Service Alert

Subject:	
NEW AUTOMATIC TRANSMISSION FLUID (ATF-A7)	Service Alert No.: SA-055/23
	Last Issued : 09/28/2023

This Service Alert supersedes the previously issued SA(s) listed below. The changes are noted in Red.

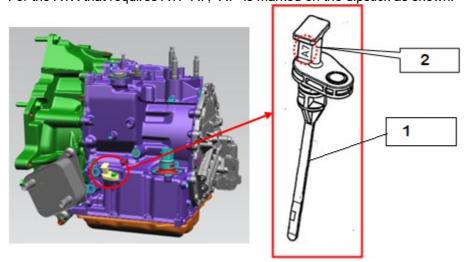
A New Automatic Transmission Fluid (ATF-A7) is being used for some 2023 and 2024 models. ATF-A7 is an extremely low viscosity formulation with low friction to achieve best-in-class fuel economy and driving performance.

- For easy identification, ATF-A7 is colored Red and ATF-FZ is colored Blue.
- There is NO interchangeability between ATF-A7 and ATF-FZ.

CAUTION: When you need to change or refill the Automatic Transmission Fluid (ATF) for this ATX (on vehicles with cylinder deactivation), always make sure to use "ATF-A7". If any ATF other than "ATF-A7" is used in the ATX, Mazda cannot guarantee the performance or reliability of the above ATX. Any malfunction caused by usage of ATF other than "ATF-A7" WILL NOT be covered by warranty. Also, DO NOT use ATF-A7 for any other ATX, otherwise it could cause serious issues with the ATX.
